ECE/TRANS/WP.29/2007/74
17 July 2007

World Forum for Harmonization of Vehicle Regulations

Proposal for Supplement 9 to Regulation No. 98

(Headlamps with gas-discharge light sources)

Figure 1

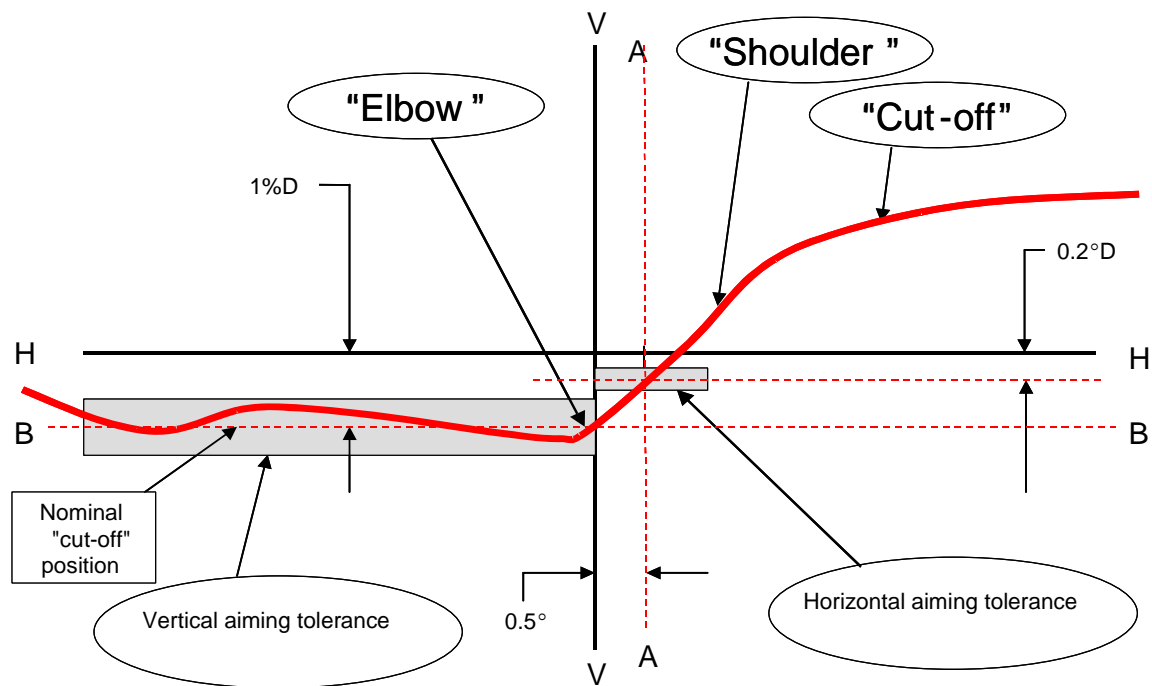
- "6.2.1. The luminous intensity distribution of the passing beam headlamp shall incorporate a "cut-off" (see figure 1 below), which enables the headlamp to be adjusted correctly for the photometric measurements and for the aiming on the vehicle.

- (a) For right hand traffic beams:
- (i) a straight "horizontal part" towards the left;
 - (ii) a raised "elbow - shoulder" part towards the right.
- (b) For left hand traffic beams:
- (i) a straight "horizontal part" towards the right;
 - (ii) a raised "elbow – shoulder" part towards the left.

- 6.2.2. The headlamp shall be visually aimed by means of the "cut-off" (see figure 1 below) as follows:
- 6.2.2.1. for vertical adjustment: the horizontal part of the "cut-off" is moved upward from below line B and adjusted to its nominal position one per cent (25 cm) below the H-H line;

- 6.2.2.2. for horizontal adjustment: the "elbow-shoulder" part of the "cut-off" shall be moved:
- (a) for right hand traffic from right to left and shall be horizontally positioned after its movement so that:
 - (b) above the line $0.2^\circ D$ its "shoulder" shall not exceed the line A to the left and
 - (c) on the the line $0.2^\circ D$ or below its "shoulder" should cross the line A and
 - (d) the kink of "elbow" should be primarily on the V-V line;

- (a) above the line $0.2^\circ D$ its "shoulder" shall not exceed the line A to the right and
- (b) on the the line $0.2^\circ D$ or below its "shoulder" should cross the line A and
- (c) the kink of "elbow" should be primarily on the V-V line."

Figure 1: Measurement of "cut-off" quality

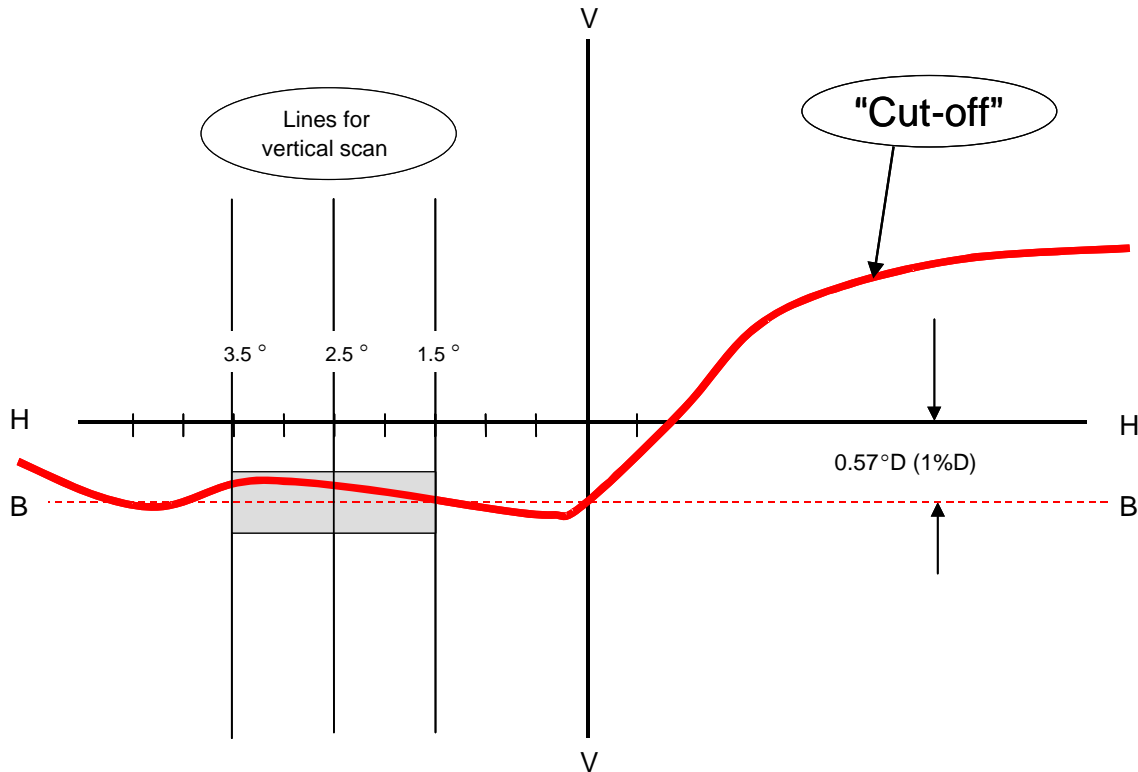
The sharpness factor G is determined by scanning vertically through the horizontal part of the "cut-off" at 2.5° from the V-V where:

The value of G shall not be less than 0.13 (minimum sharpness) and not greater than 0.40 (maximum sharpness).

The part of the horizontal "cut-off" that serves for vertical adjustment shall be horizontal between 1.5° and 3.5° from the V-V line (see figure 1 below).

- (a) The inflection points of the "cut-off" gradient at the vertical lines at 1.5° , 2.5° and 3.5° shall be determined by the equation:

- (b) The maximum vertical distance between the inflection points determined shall not exceed 0.2° .

Figure 2: Instrumental vertical and horizontal adjustment- horizontal line scan method

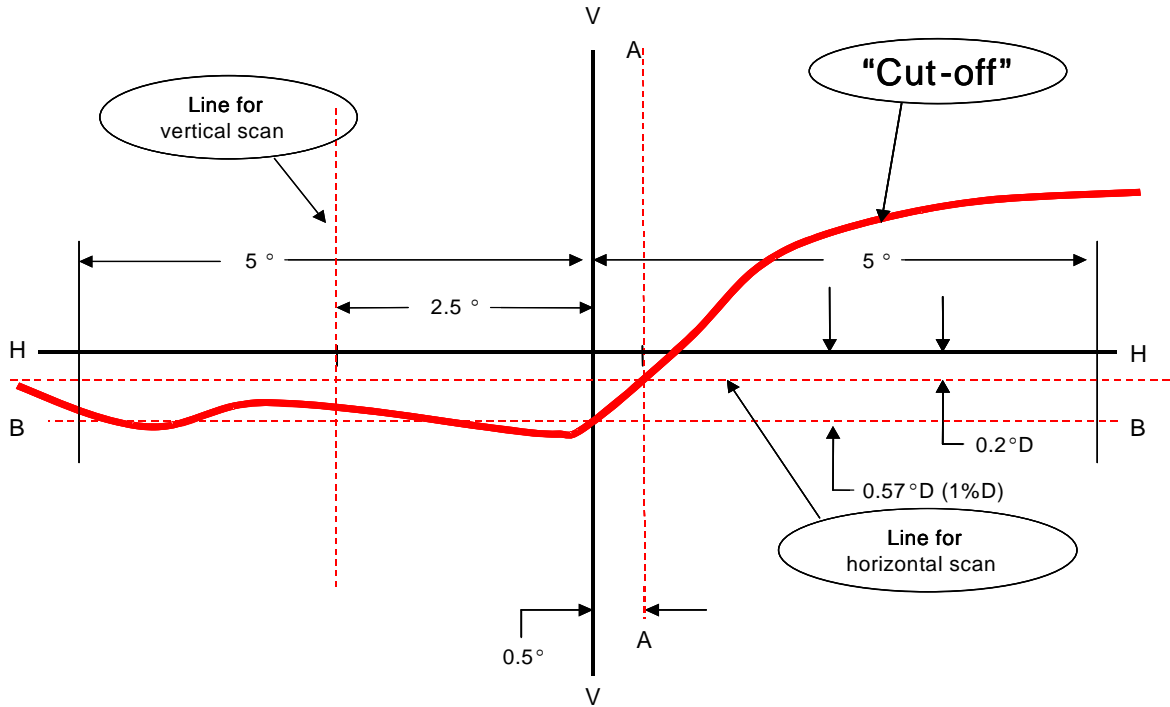
Moving upward from below the line B (see figure 2 below), a vertical scan is carried out through the horizontal part of the "cut-off" at 2.5° from V-V. The inflection point (where $d^2(\log E) / dv^2 = 0$) is determined and positioned on the line B situated one per cent below H-H.

- (a) The "0.2 D line" method (see figure 2 below).

A single horizontal line at 0.2° D shall be scanned from 5° left to 5° right after the lamp has been aimed vertically. The maximum gradient "G" determined using the

formula $G = (\log E_{\beta} - \log E_{(\beta + 0.1^{\circ})})$ where β is the horizontal position in degrees, shall not be less than 0.08.

The inflection point found on the 0.2 D line shall be positioned on the line A.

Figure 3: Instrumental vertical and horizontal adjustment-three line scan method

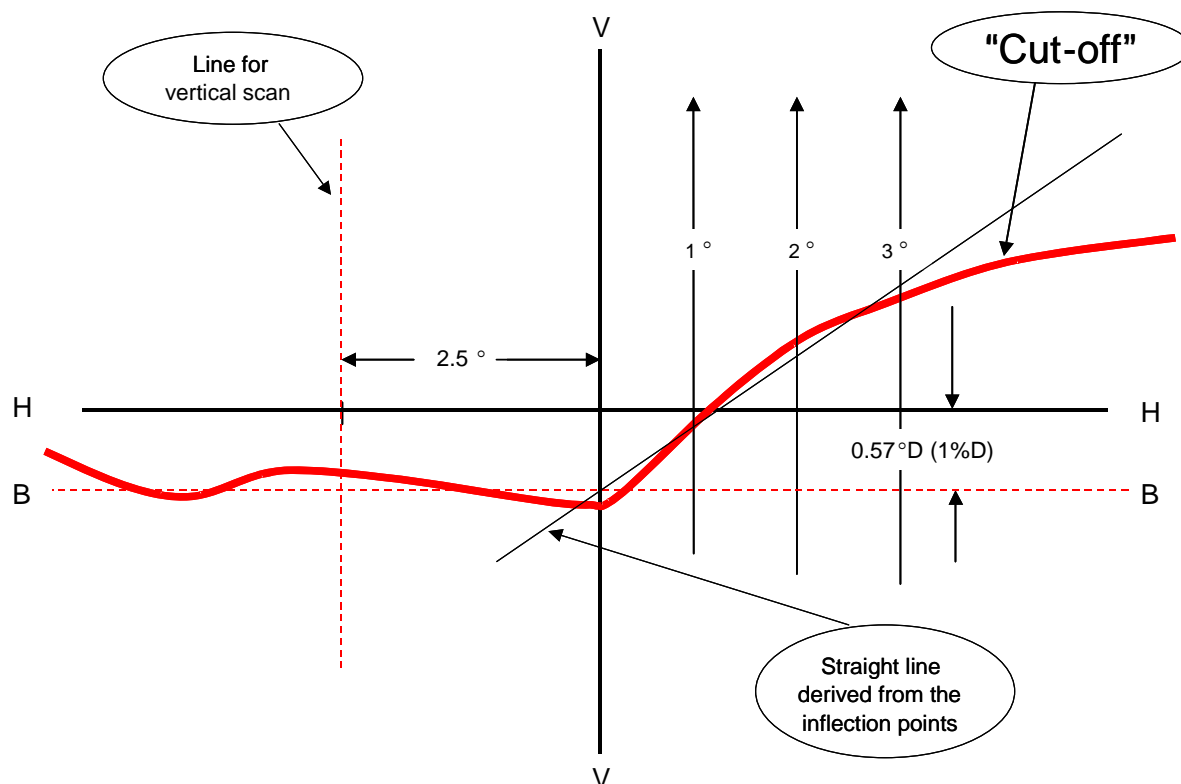
Three vertical lines shall be scanned from 2° D to 2° U at 1°R, 2°R, and 3°R after the lamp has been aimed vertically. The respective maximum gradients "G" determined using the formula:

where β is the vertical position in degrees, shall not be less than 0.08. The inflection points found on the three lines shall be used to derive a straight line. The intersection of this line and the line B found while performing vertical aim shall be placed on the V line.
